# AMERICAN SELF STORAGE DEVELOPMENT PLAN

## SOUTHWEST BLVD.

## GROVE CITY, FRANKLIN COUNTY, OHIO

Staff has reviewed your development plan application for American Self-Storage located on Southwest Boulevard. The control number for this application is #201603280021 and should be referenced on any future correspondence concerning this matter.

| APPROVED BY: RAB | SHEET:   | 3A OF 6    |

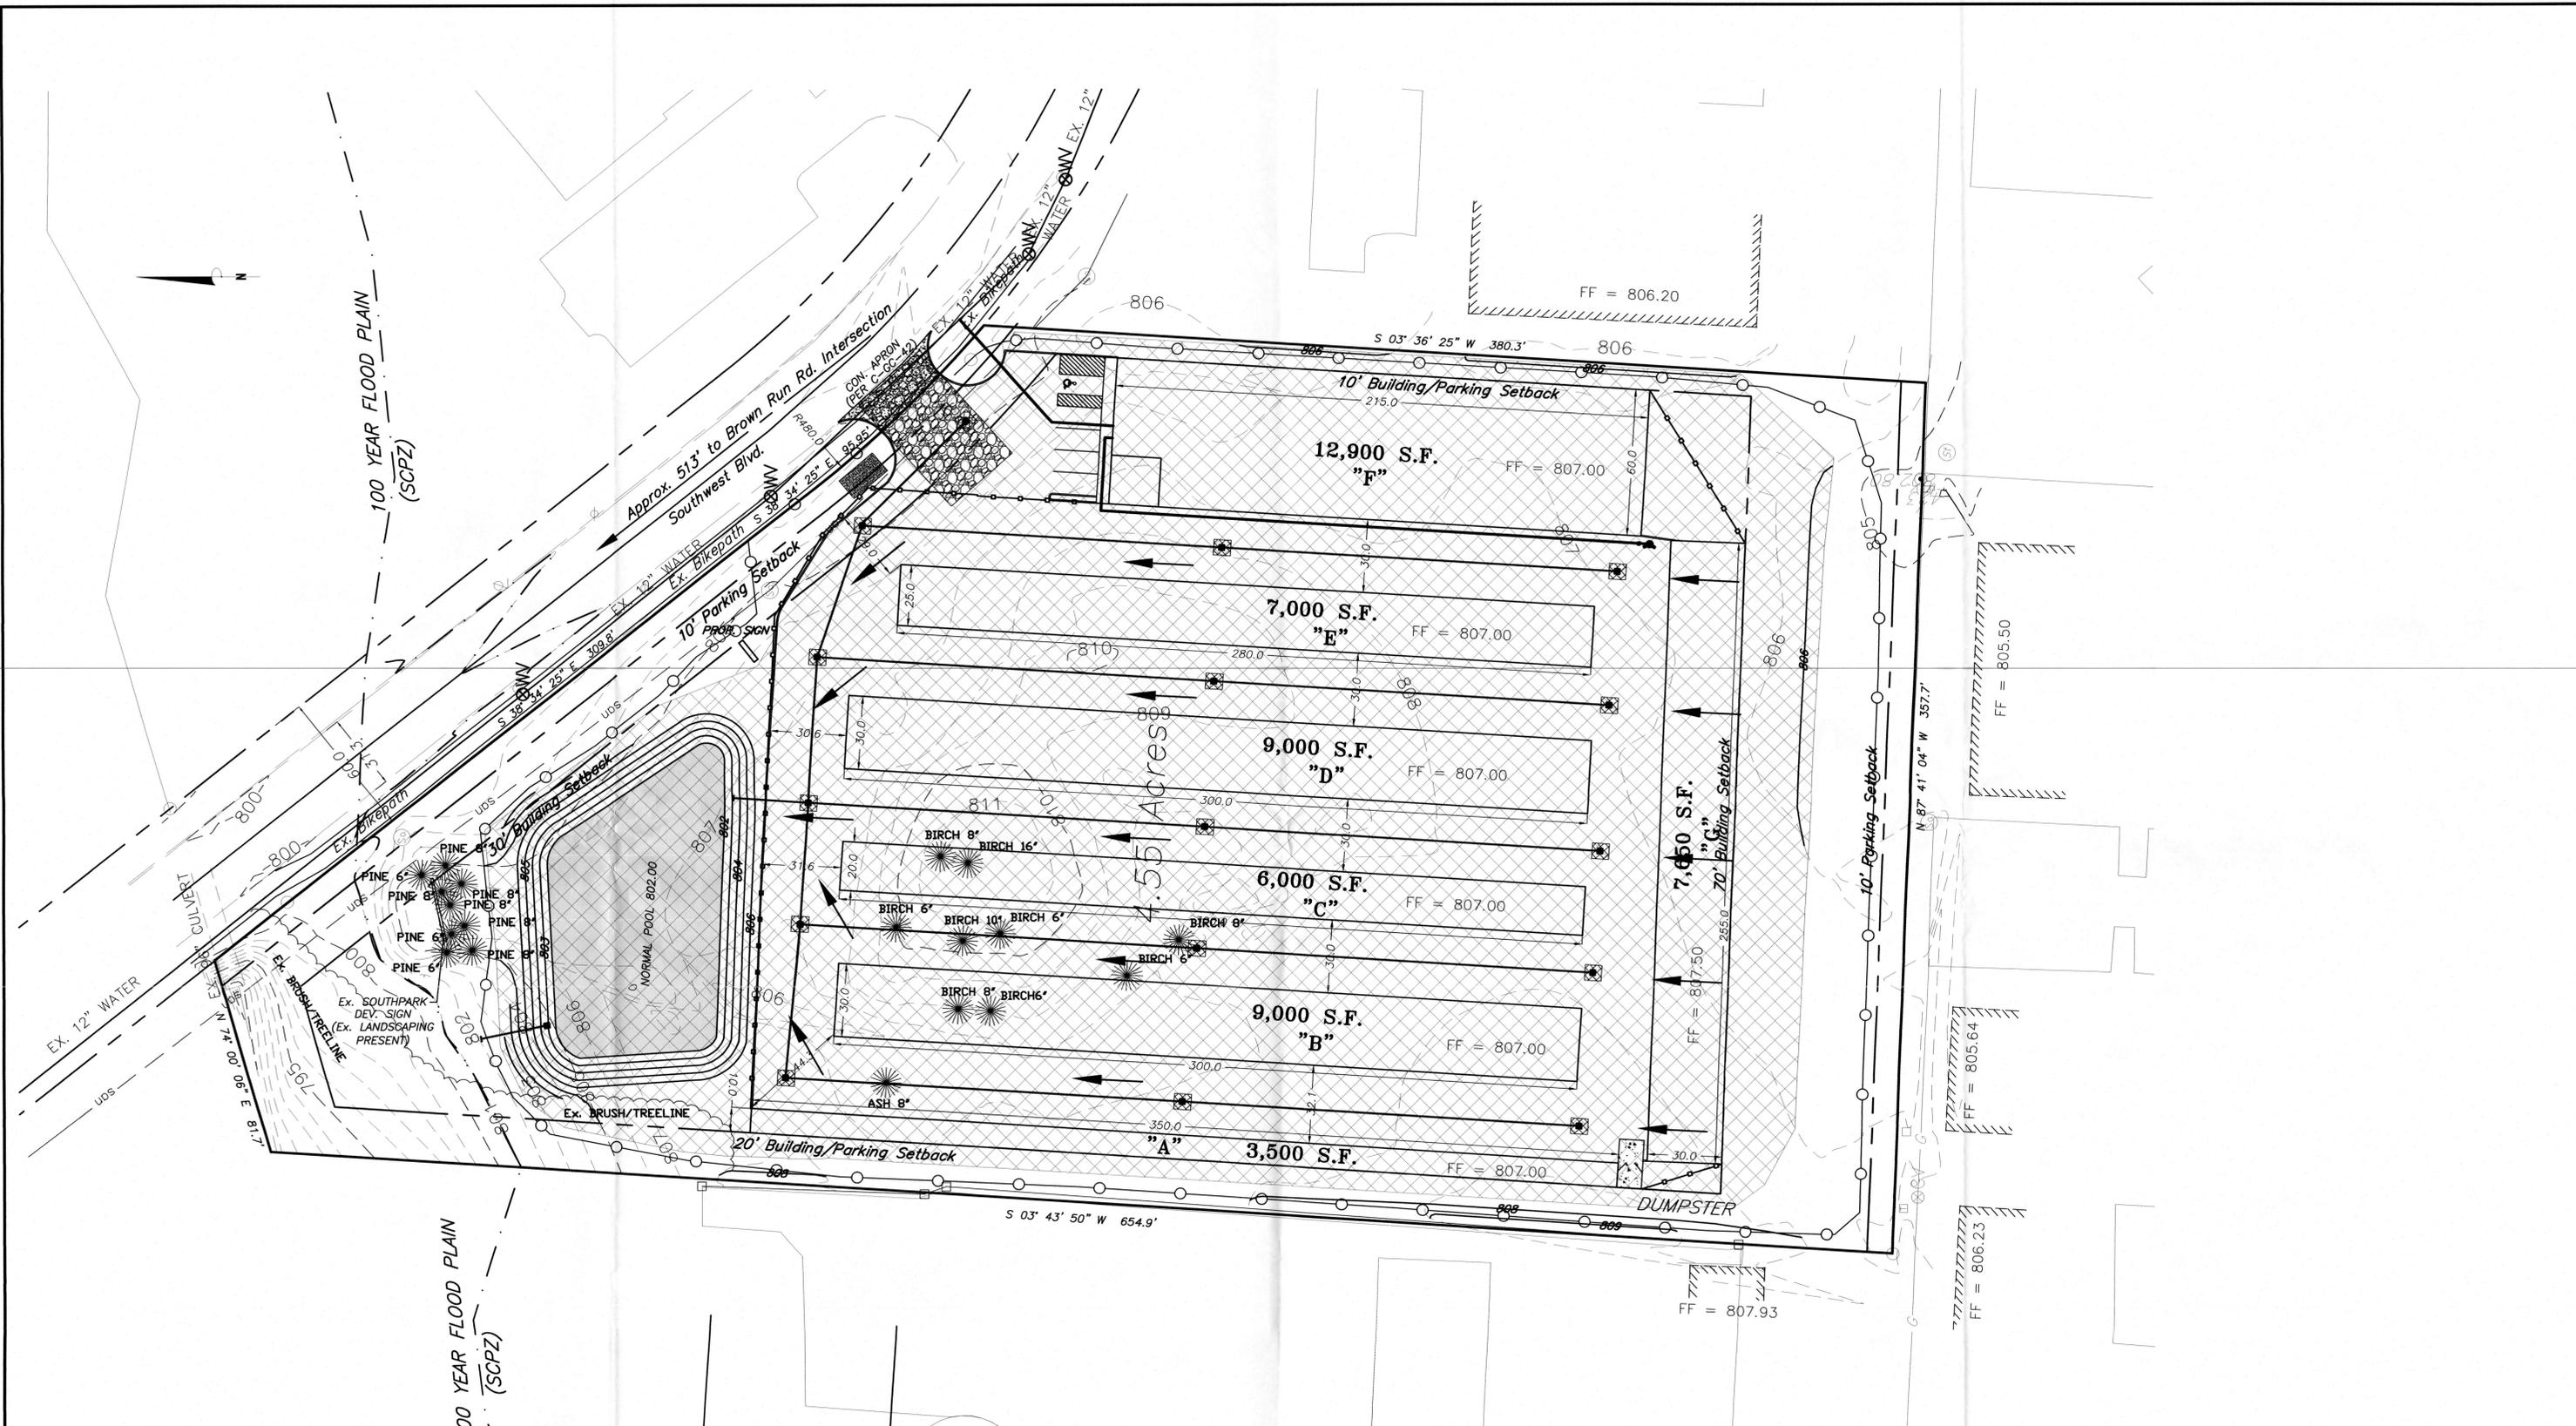
13. A tree inventory needs to be completed on any tree located on the property that is 6" or larger dbh. The plans need to show which trees are going to be removed during the construction process and there

needs to be a plan stating how the trees that are to remain, will be protected during the construction process.

13. SH3A has been added to the plan set, which contains the tree inventory that was performed by the Developer.
14. A landscaped peninsula has been added along the west end of the proposed parking. Landscaping has also been added along the east end of the aforementioned parking.

**LANDSCAPING PLAN**

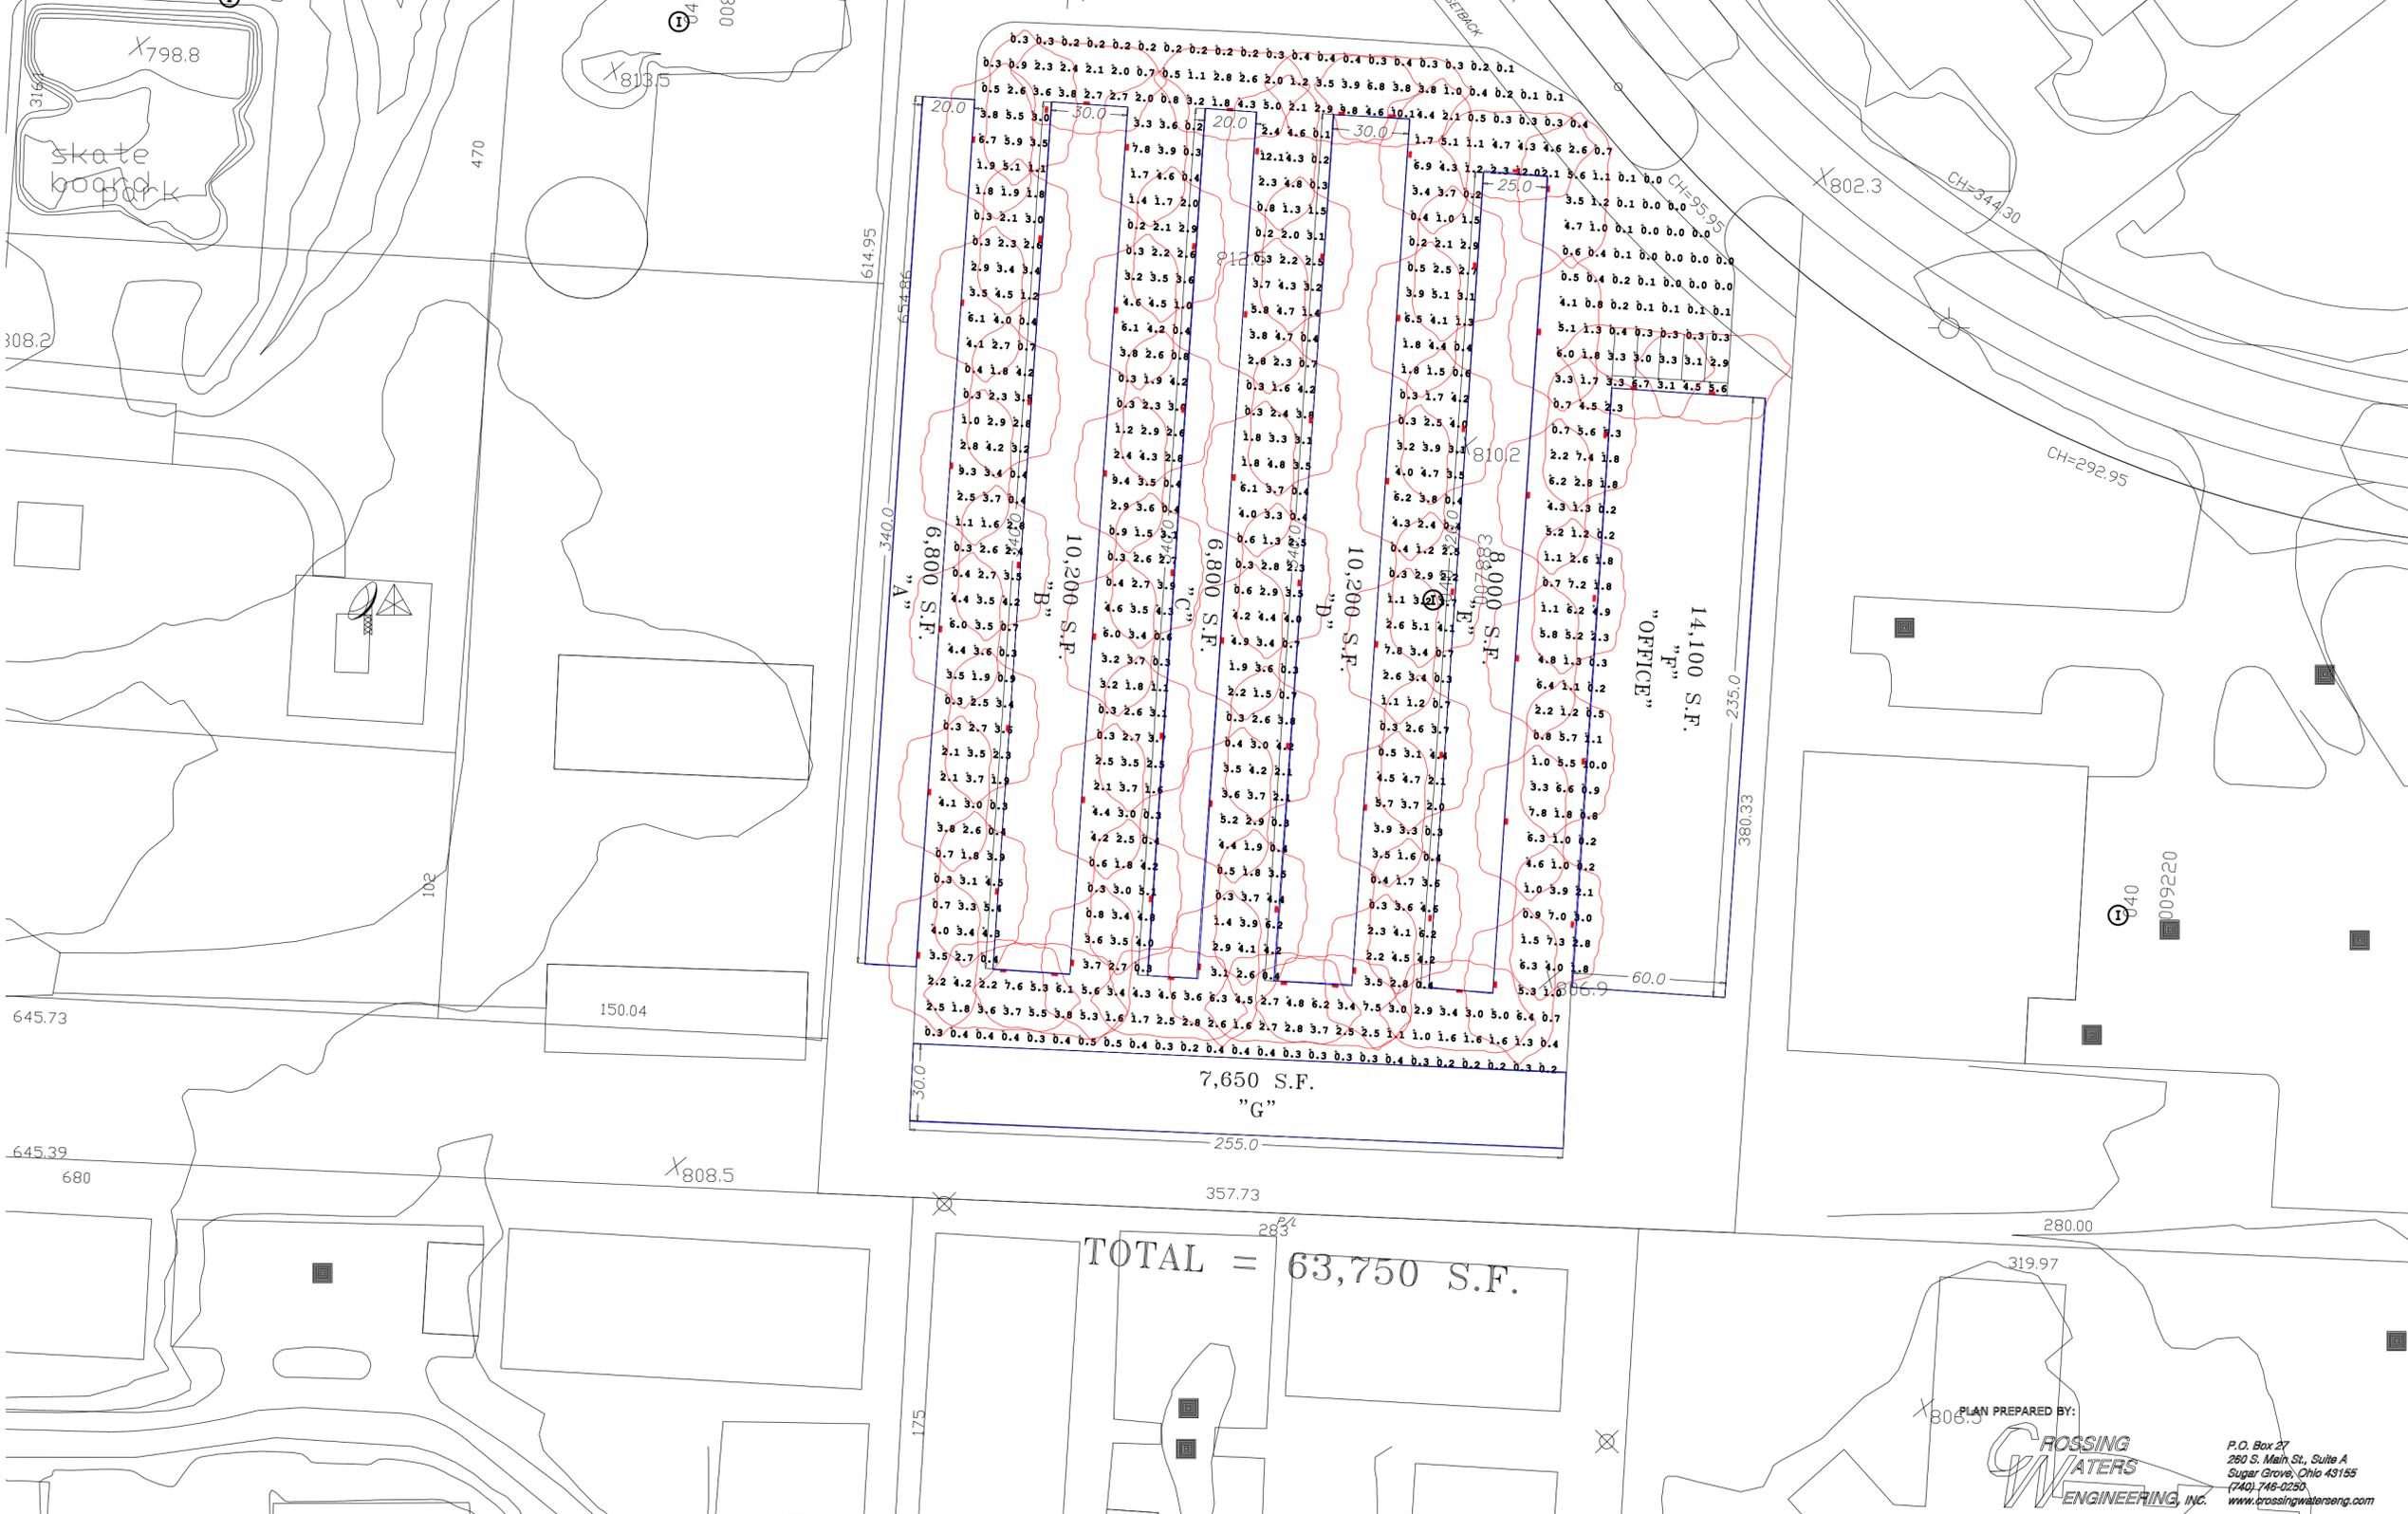
2. Due to the prominence of the proposed pond along Southwest Boulevard and the fact that this site acts as the western gateway to the Southpark area, staff recommends the landscaping around the pond be greatly increased. Landscaping in the form of trees, shrubs, and other plantings should be installed around the entire pond with a variety of plantings to create an aesthetically pleasing site feature.

15. All service structures, including but not limited to electric transformers, A/C units and dumpsters need to be screened by a continuous 100% opaque landscape hedge, solid fence or wall. If walls or fences are used, supplemental landscaping is required: 36" height minimum plantings at 5' maximum spacing around the enclosed portion of the perimeter screen. A note should also be added to the landscape plan stating that all service structures will be screened per the requirements of section 1136.08

16. A minimum of 20 square feet of landscaped area is required for every 50 lineal feet of building perimeter-adjacent to the building(s) and contain shrubs, ground cover or other ornamental plantings 24" minimum in height at installation and maximum spacing of 5' on center.

2. Landscaping has been greatly added around the proposed pond, due to its prominence to the entrance of the Southpark Development. See SH6.
3. Comment addressed by the Developer.

15. Known service structures have been appropriately screened, and a note has been added on the plan stating that "All service structures shall be screened per the requirements of Section 1136.08." See SH6.

16. 1819 S.F. of additional ground cover landscaping has been added to the plan. See SH6.
17. A landscaped area has been added to the plan surrounding the proposed ground-mounted sign. See SH6.
